Duffield Road, Sonning

Reserved Matters Transport Statement

Stage 1 Completion of Preliminary Design Road Safety Audit

Sonning Golf Club, Sonning

DRAWN: JB	CHECKED: BH	APPROVED: BH
PROJECT No: ITB210997	SCALE @ A3: 1:1000	DATE: 26.02.26
DRAWING No: ITB210997-GA-001	REV: F

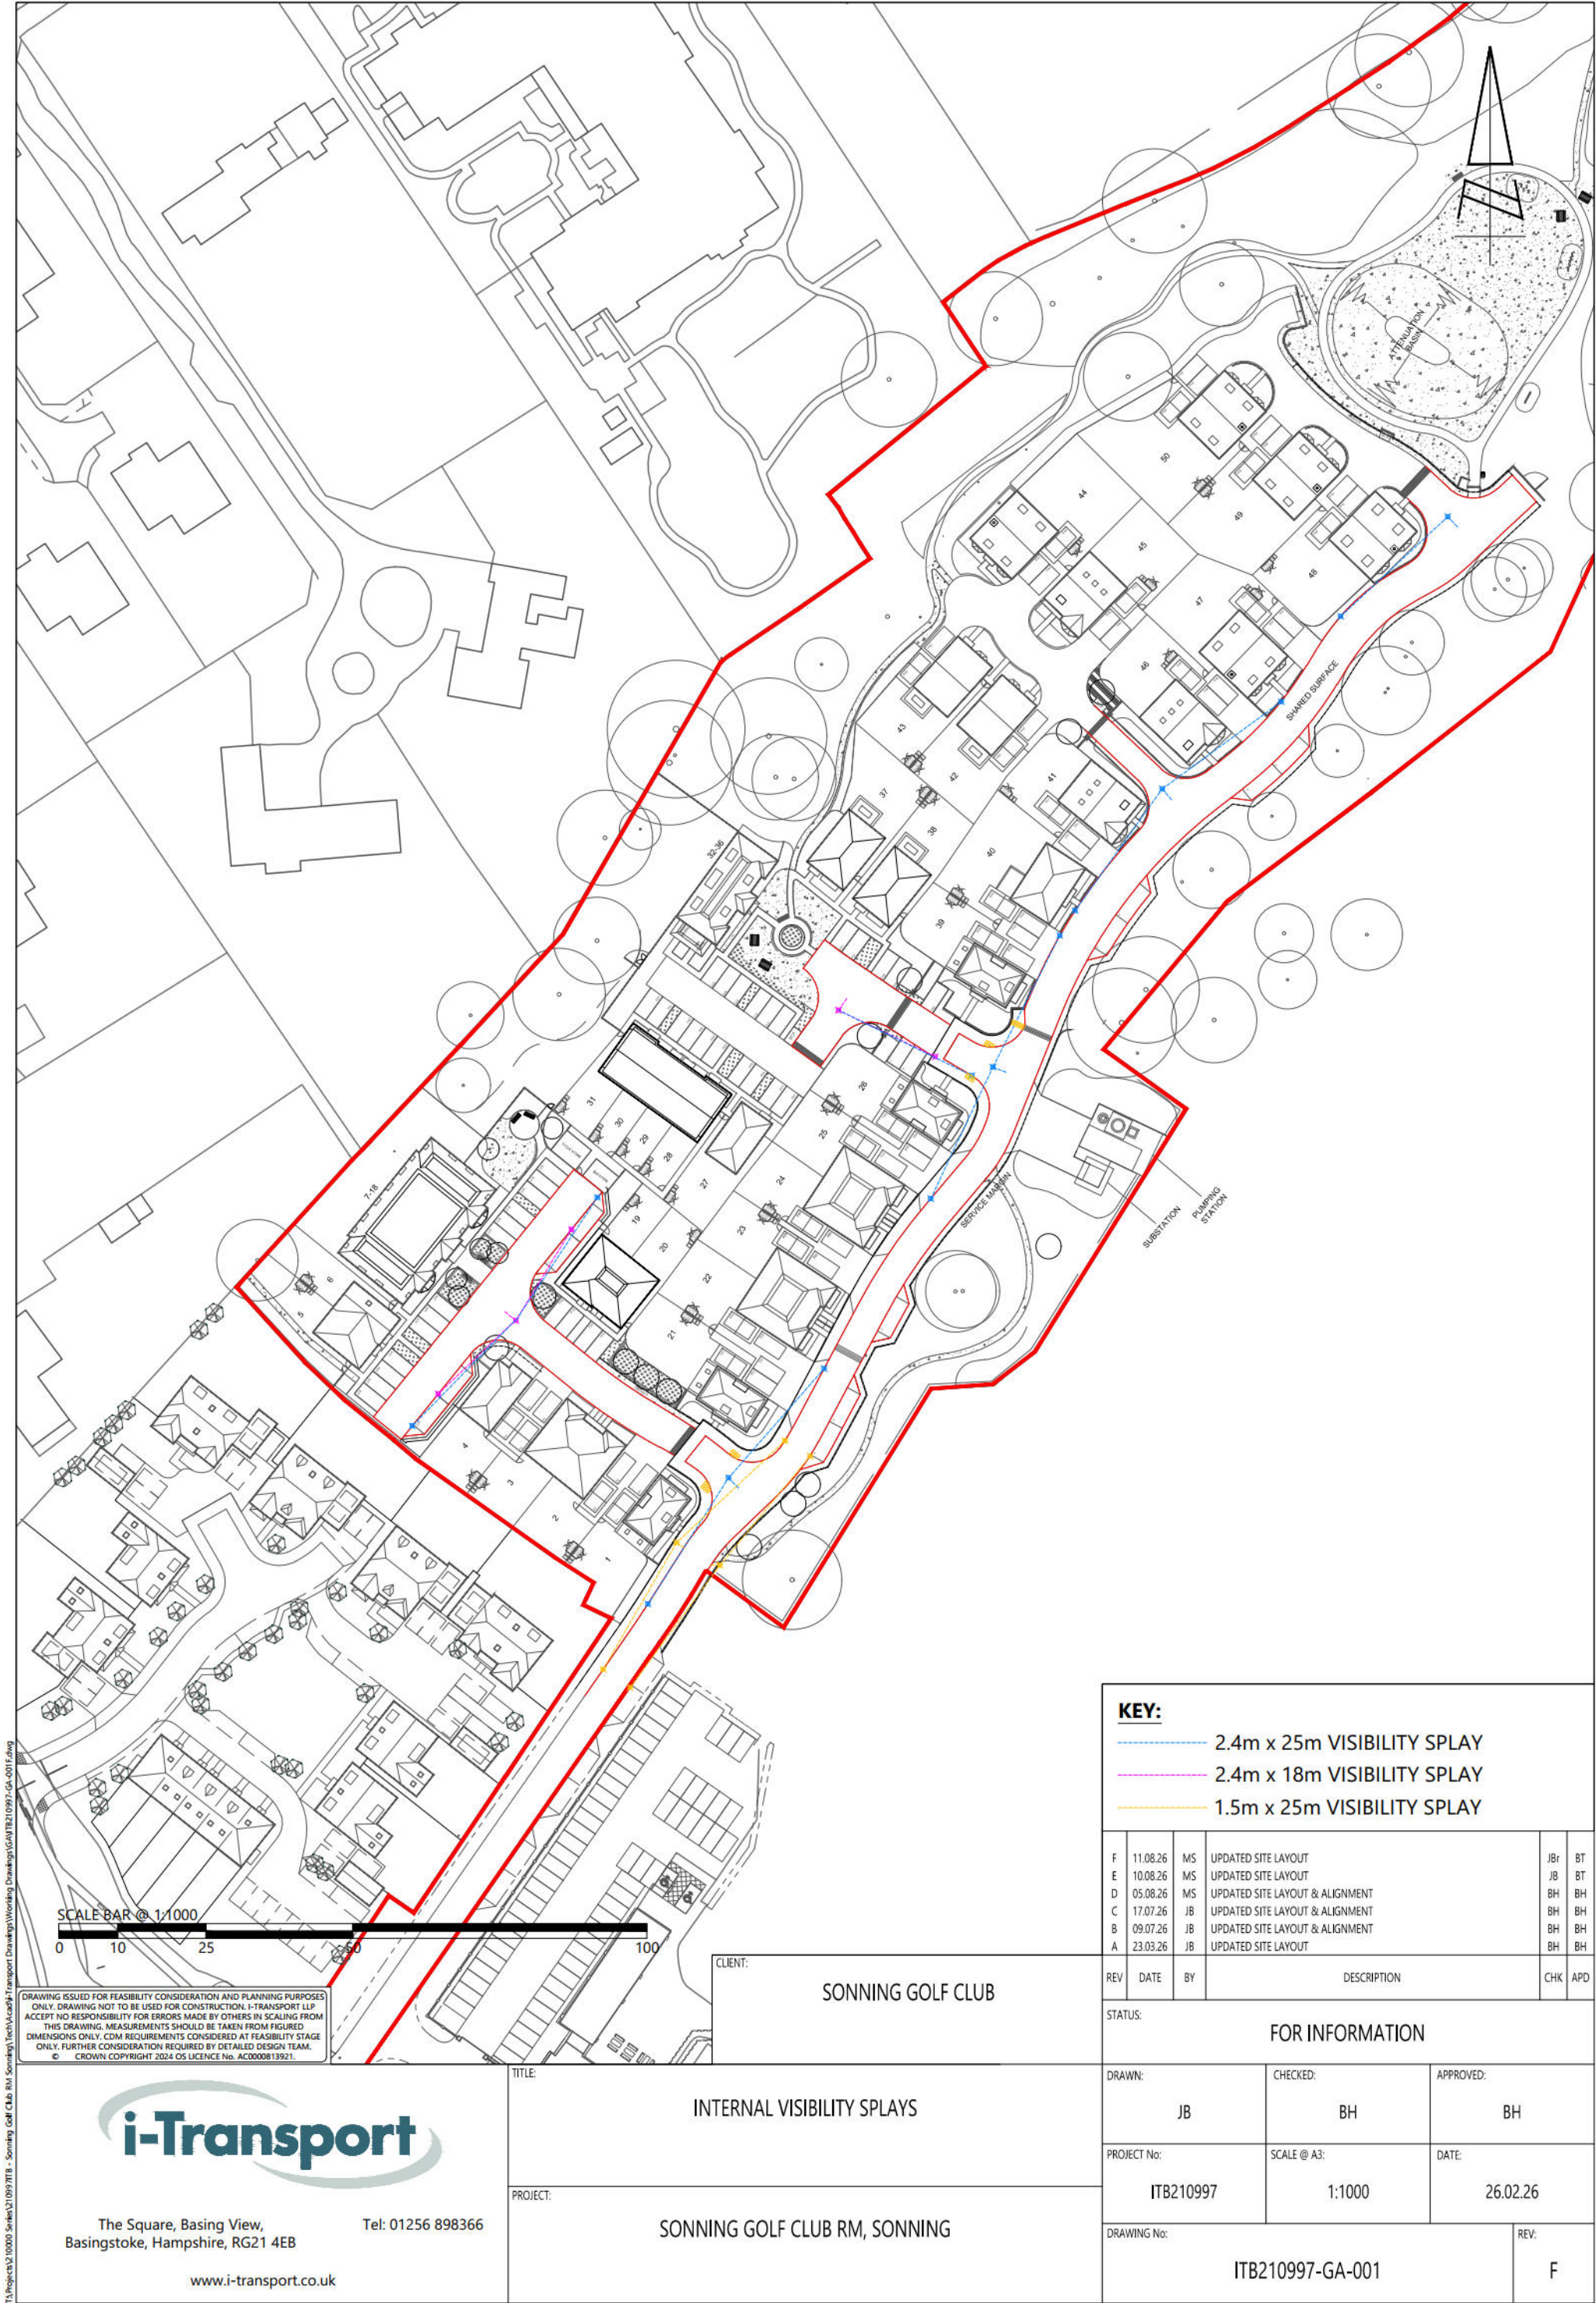
Summary: Visibility could become restricted

The scheme includes the proposed internal highway layout for a development comprised of 50 residential dwellings. The scheme drawings illustrate visibility splays at junctions of 2.4 x 25 metres, consistent with the proposed design speed of 20mph. It is noted that visibility splays at two junctions are shown to encroach a small number of parking spaces, this should be acceptable as motorists in those locations are highly likely to be travelling at 20mph on the approaches to the junctions, however, in some locations the visibility splay envelopes appear to encroach property frontages. The Audit Team have concerns that any boundary treatment, or items within the frontages, in excess of 600mm in height, will limit the level of achievable visibility, which could lead to side impact collisions.

It is recommended that any planting or erecting of items within the visibility envelopes is restricted to heights of no more than 600mm to allow adequate visibility to be achievable at all times.

Soft landscaping proposed in front gardens will either be grass or low level planting and below 600mm. Estate railing is also proposed to front garden boundary treatments but visibility can be achieved through the estate railing. An example of the estate railing is shown in the image below.

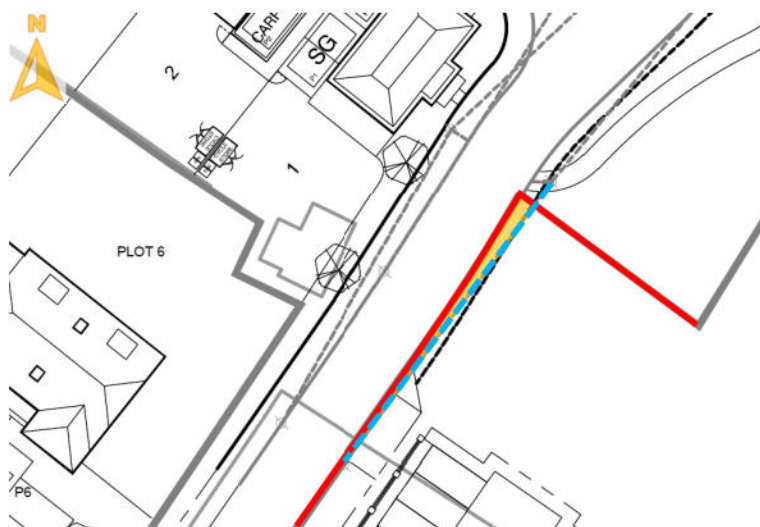
4.4.3	Problem
Location:	Crossing outside plot 1
Summary:	Restricted visibility at a proposed crossing point
The scheme includes the proposed internal highway layout within a development of 50 residential dwellings that is to consist of general carriageways with footways, shared surface carriageways and a number of footpaths. An uncontrolled crossing point is illustrated outside plot 1 linking a footpath that runs along the southern side of the proposed development with the proposed footway on the northern side of the access road. Pedestrian visibility splays of 1.5 x 25 metres have been illustrated, is in accordance the proposed design speed of 20mph. It is noted, however, that the visibility splay to the south extends beyond the redline boundary and into third party land. The Audit Team have concerns the illustrated visibility may not be achievable, resulting in restricted visibility. Restricted visibility could result in a pedestrian entering the

carriageway into the path of an approaching motorist when it is unsafe to do so, leading to a vehicle to pedestrian collision.

It is recommended that appropriate visibility is achievable.

DESIGN ORGANISATION RESPONSE provided by i-Transport on the 30 July 2026 following formal issue of this Stage 1 Completion of Preliminary Design Road Safety Audit on the 24th July 2026.

Whilst the visibility is outside of the redline for phase 2 (the proposed new homes), it is within the redline for phase 1 (the new access and reconfigured car park). It is therefore achievable within land controlled by the developer and can be provided in perpetuity.
